Sydney Olympic Park New High School

Architectural Response to SDRP Report

Courtyard facades

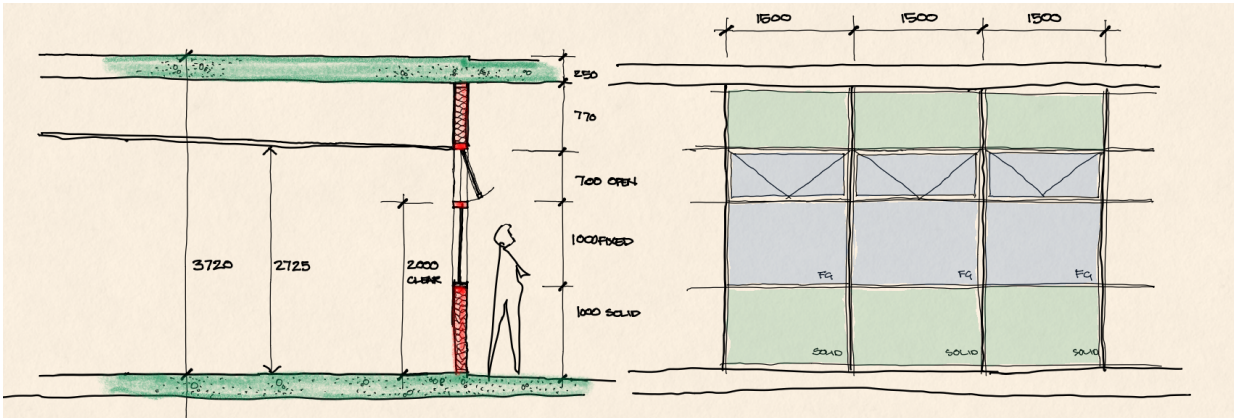
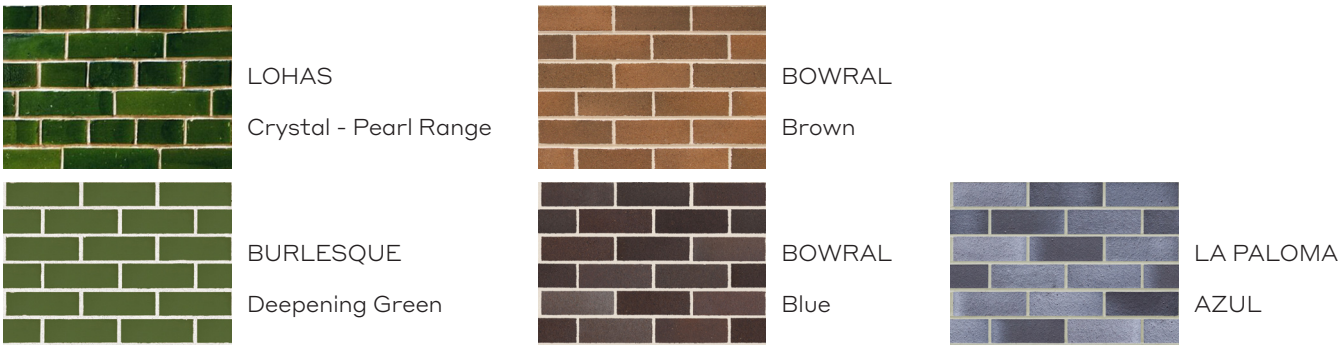
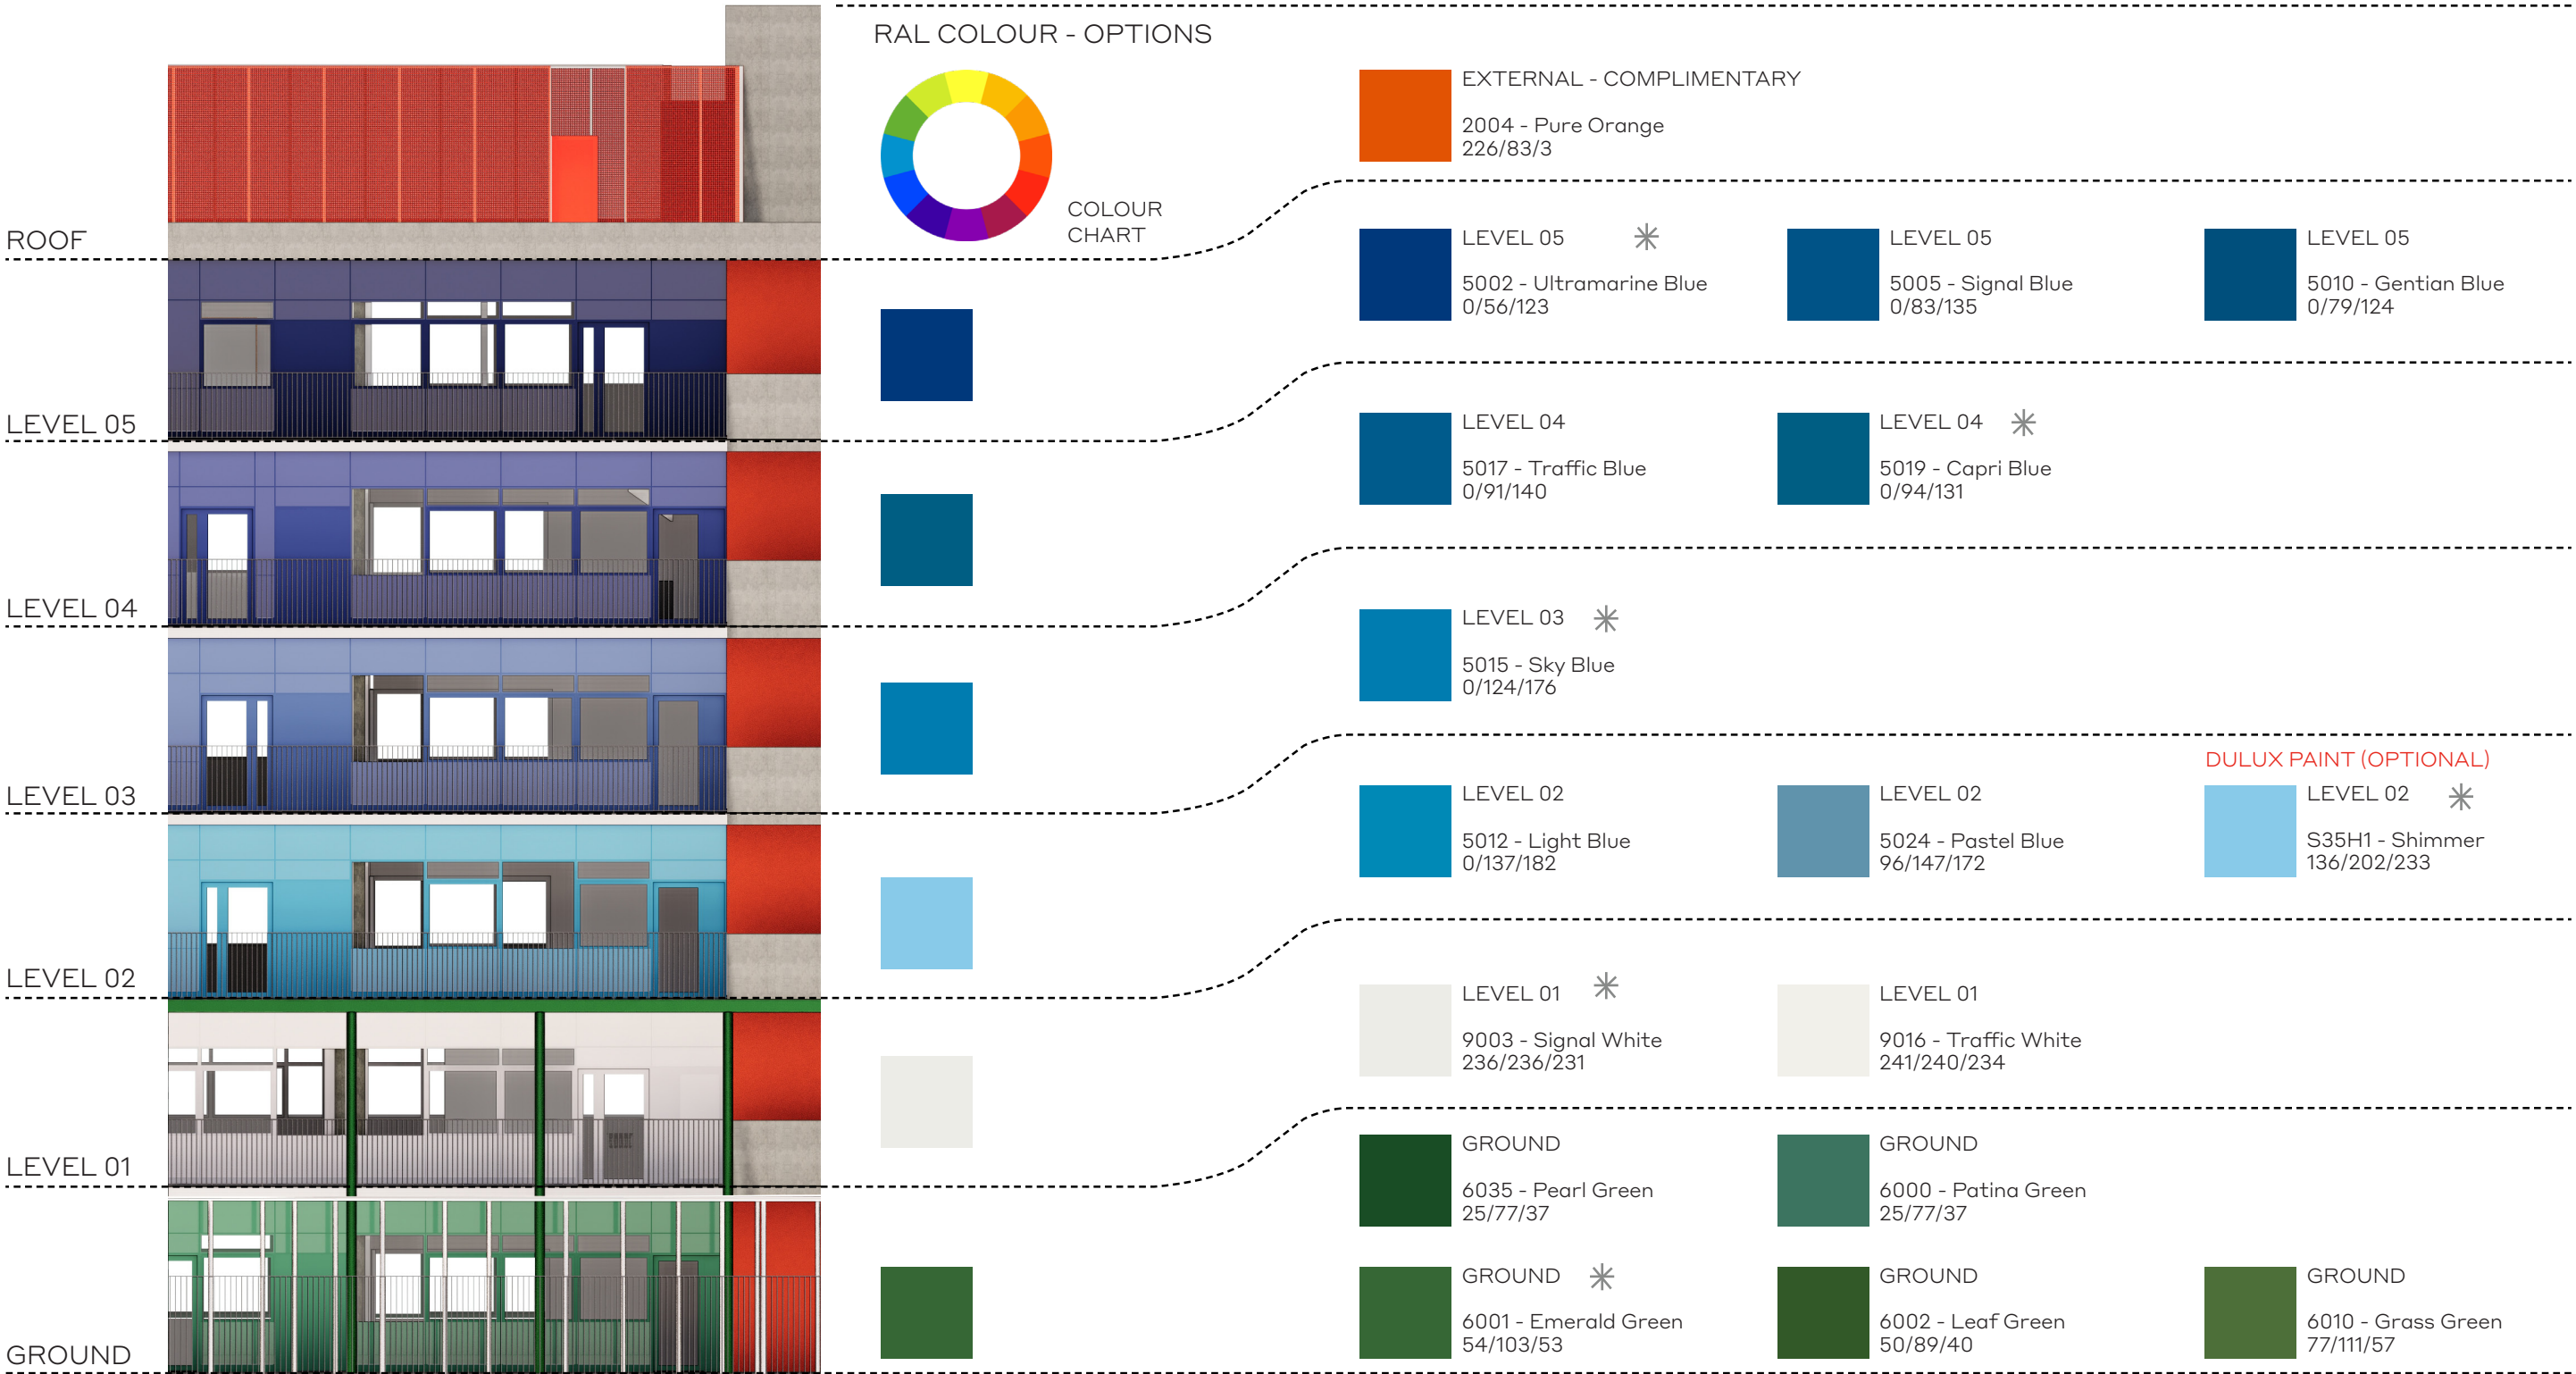
Comment: Courtyard facades – Provide further detail of the materials and form of the internal courtyard elevations, including the classroom facades and the external walkways.

Courtyard-facing facades have been developed through the integration of perforated vent panels, refinement of the colour scheme, and the placement of operable awning windows to animate the facade.

High bay windows will benefit the articulation of the facade as well as the prevention of students hitting them.

Inclusion of louvres along the facade add an extra layer of articulation.

Solar protection

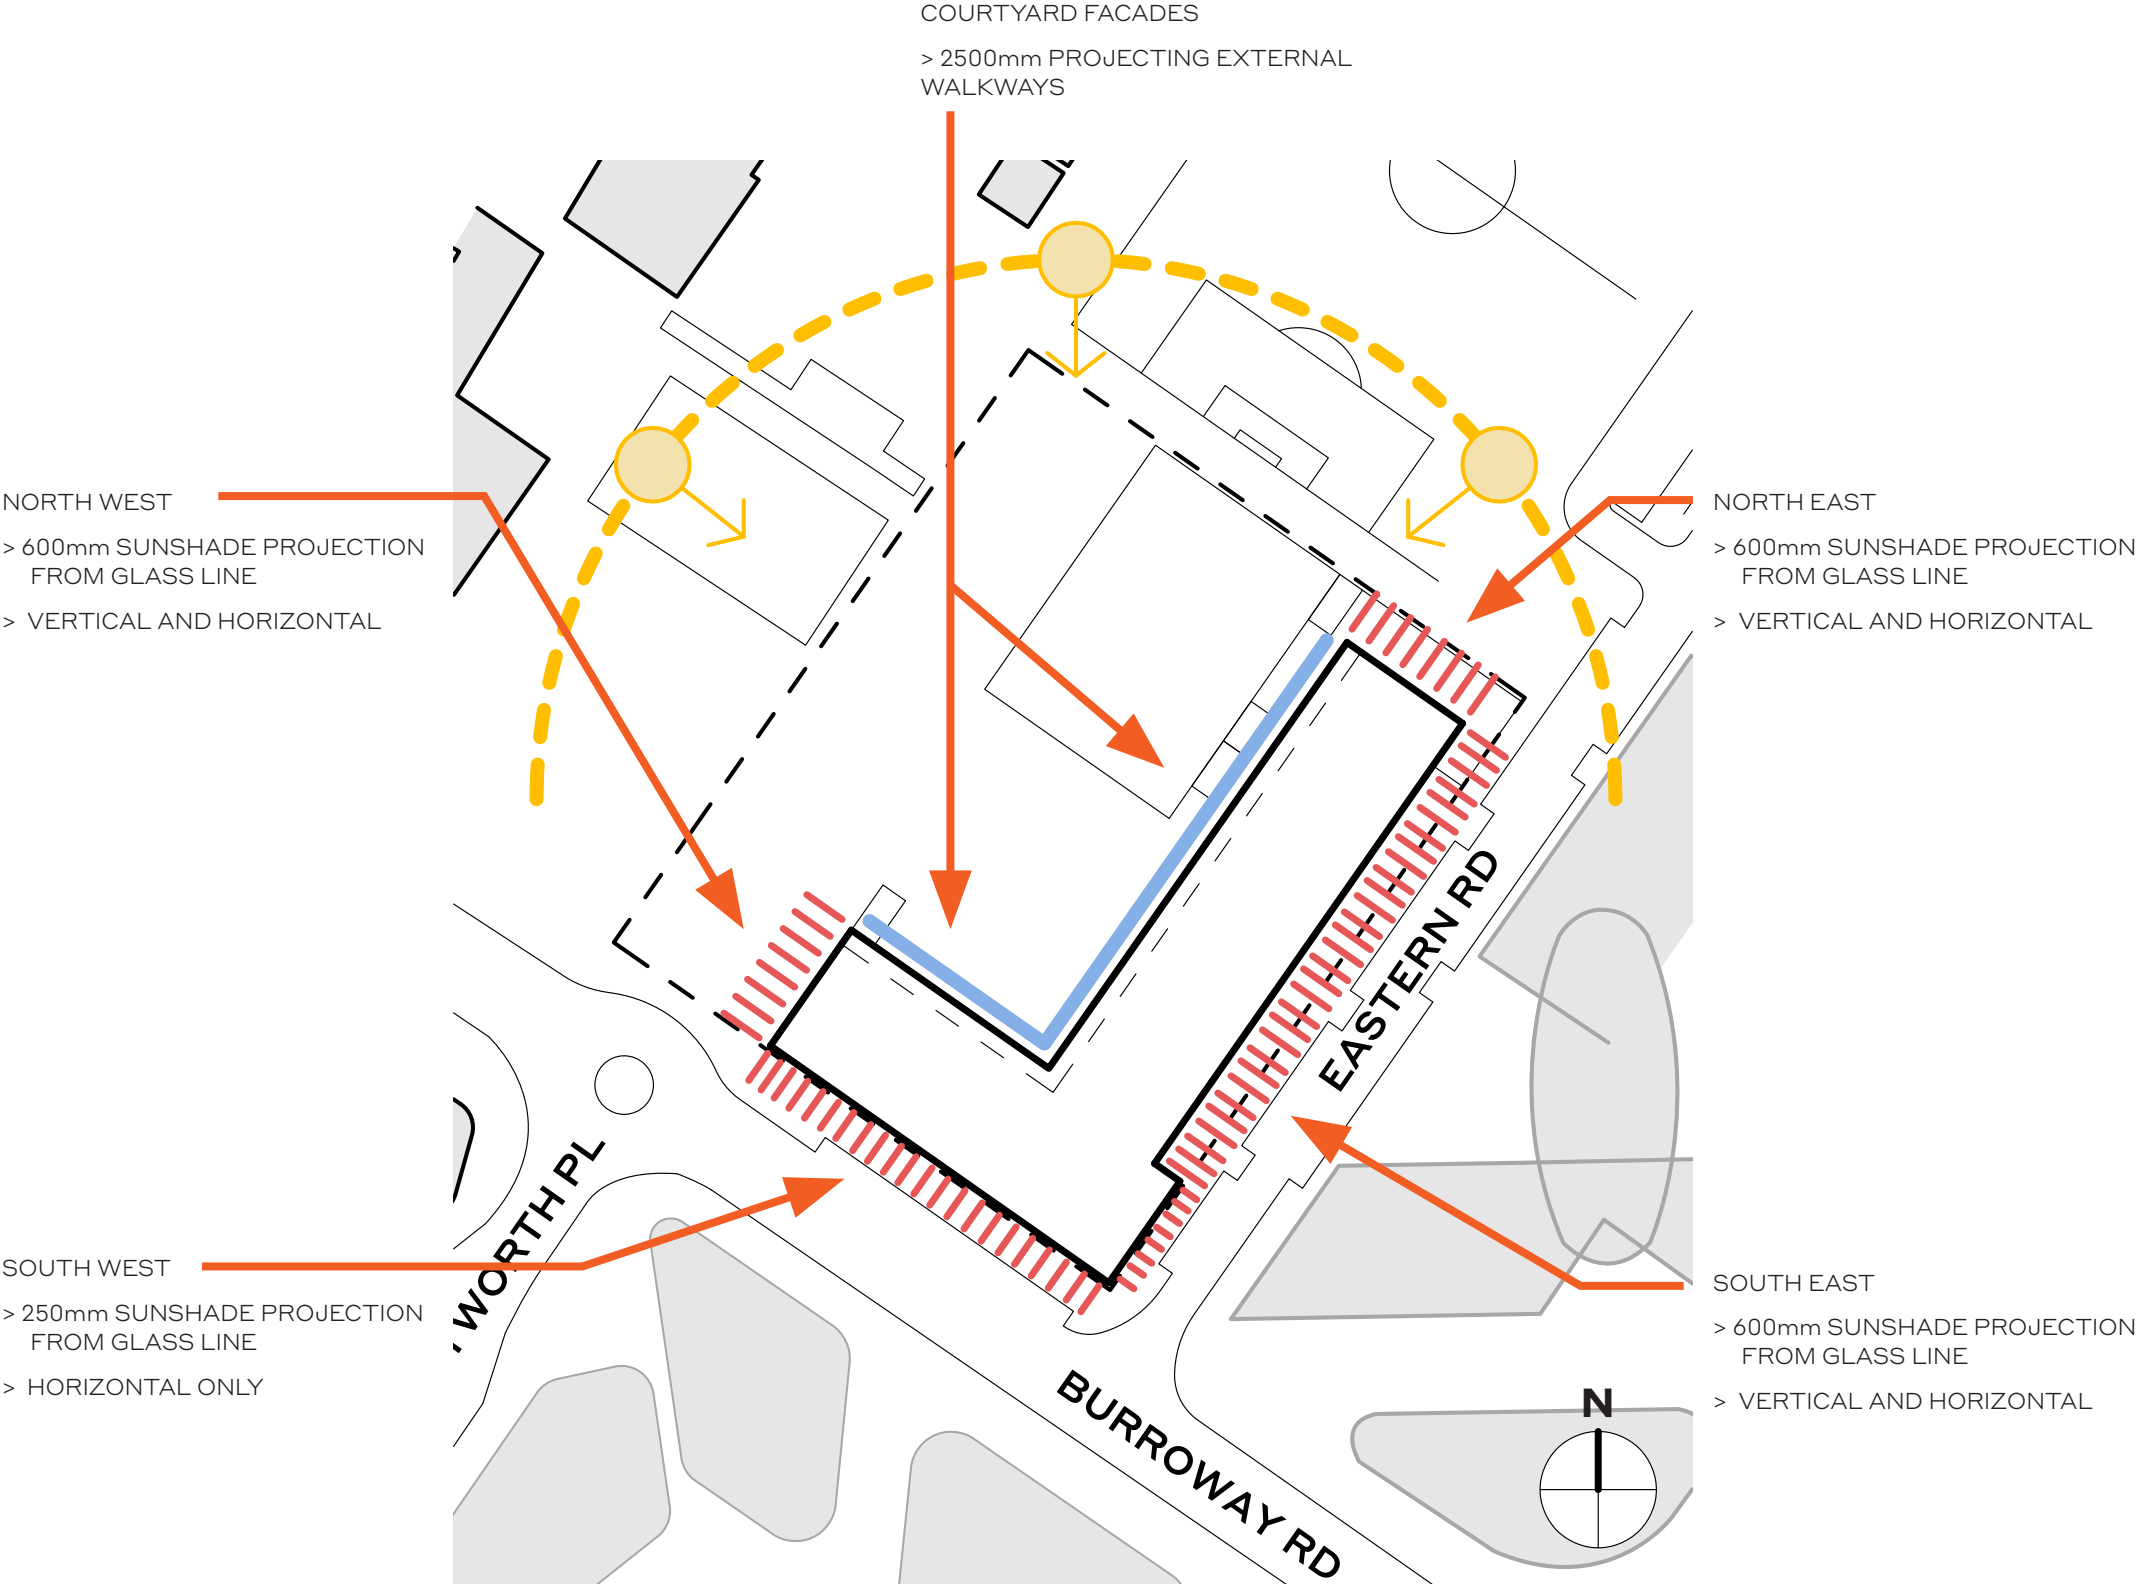
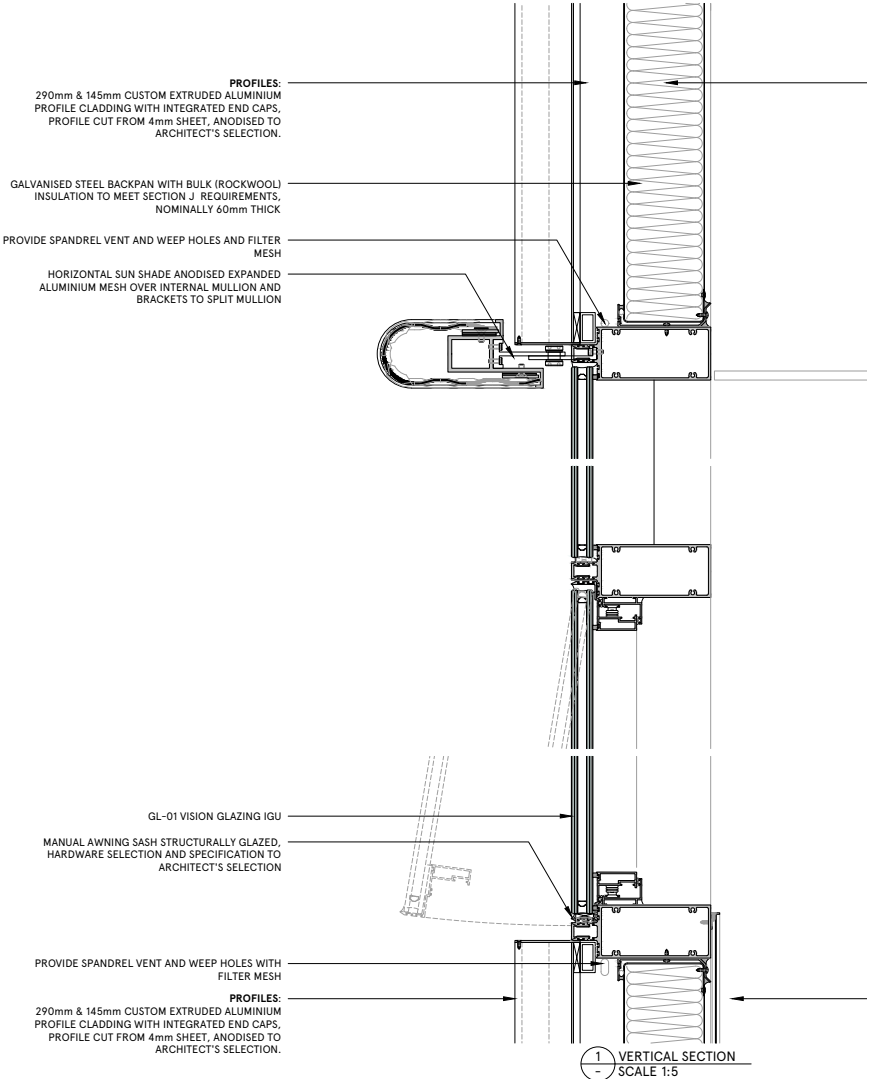
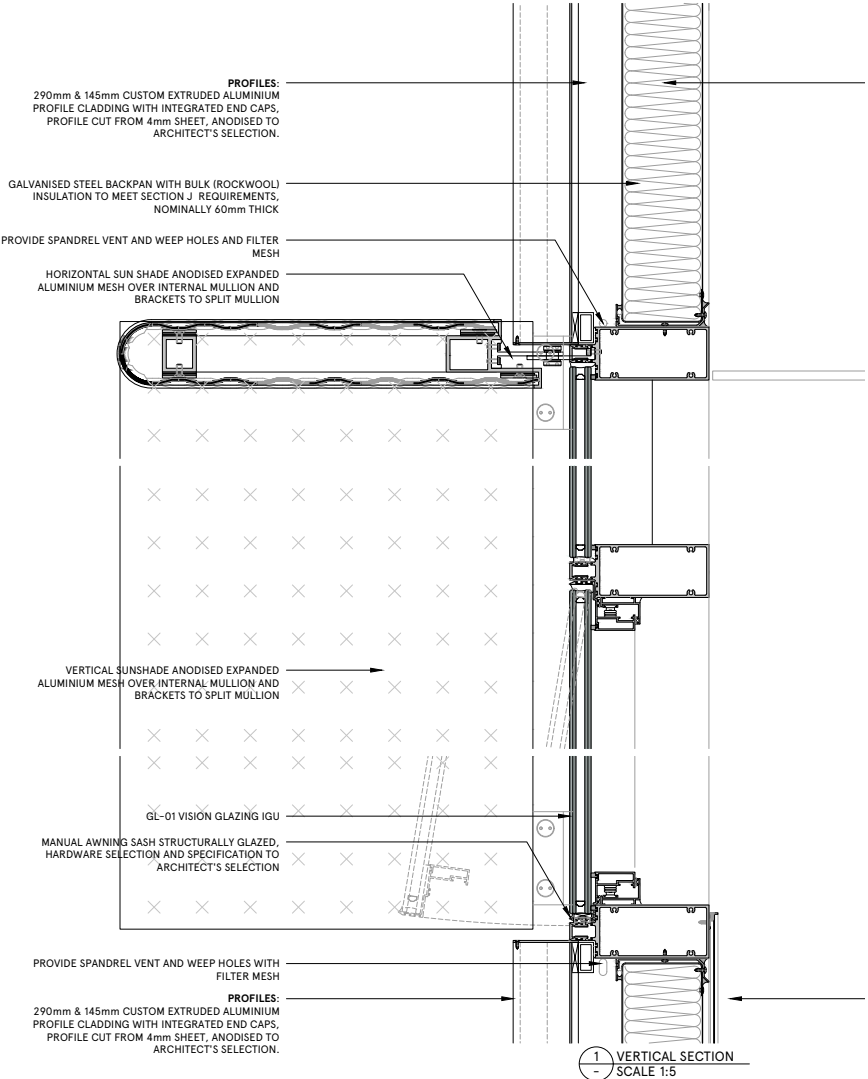
Comment: Solar protection – Illustrate how the facades, awnings and external walkways provide protection to teaching spaces from direct sun during school hours.

The building's facades have been designed to optimise solar protection and daylighting to internal spaces. To summarise the project's strategy for solar protection, there are three façade types within the project.

The first comprises 2500mm-deep, projecting concrete external walkways; these are located along the long facades overlooking the school courtyard. This type covers the majority of the façade area within the project that is exposed to harsh northern sun.

The second comprises a combination of vertical and horizontal sun shades, each projecting 600mm from the façade, and matching the dimension of each window. This type is located on the north-east and north-west façade (the “ends” of the teaching blocks), and on the south-east façade overlooking the proposed eastern road.

The third comprises a horizontal sun shade projecting 250mm from the head of each window. This type is located only on the south-west façade that overlooks Burroway Rd.

The design of these sun shading devices (their placement, orientation and dimension) is based on detailed analysis by the project's ESD consultant.

Tree canopy

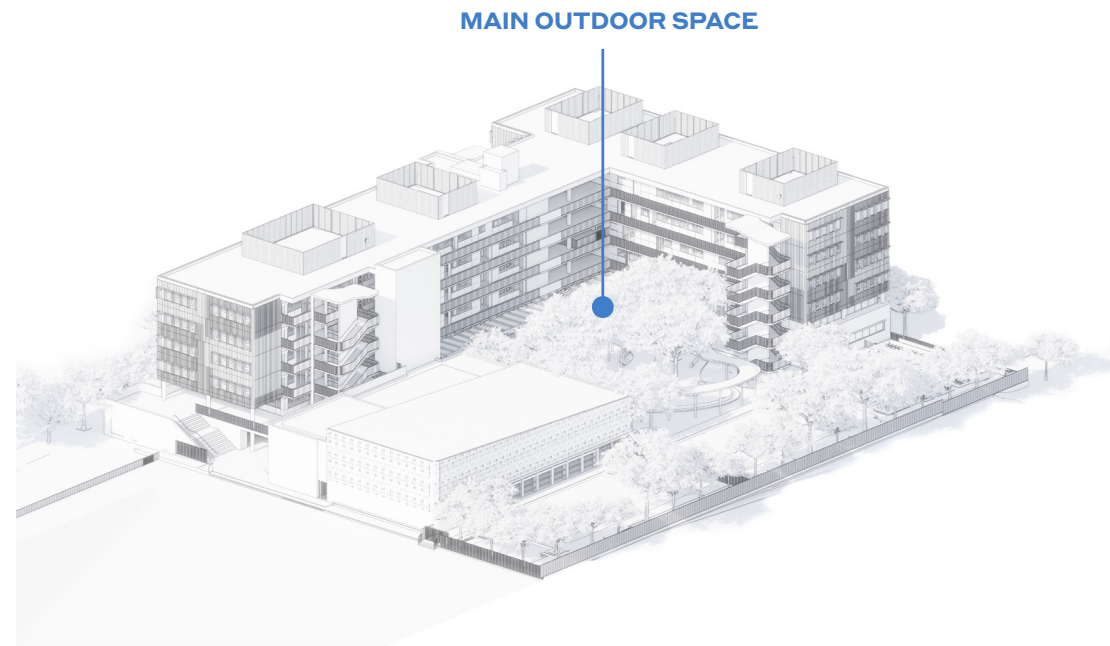
Comment: Provide a detailed landscape strategy including tree canopy cover and planting palette. A minimum target of 30% tree canopy cover is encouraged.

Within the site boundary the current landscape design proposes an increased tree canopy cover of 23% of total outdoor open space. The inclusion of architectural arbours and shade canopies increase the total canopy cover by an additional 5%. An additional 3% ground level COLA is proposed by architects. Total 31% cover.

A detailed planting plan and schedule have been provided.
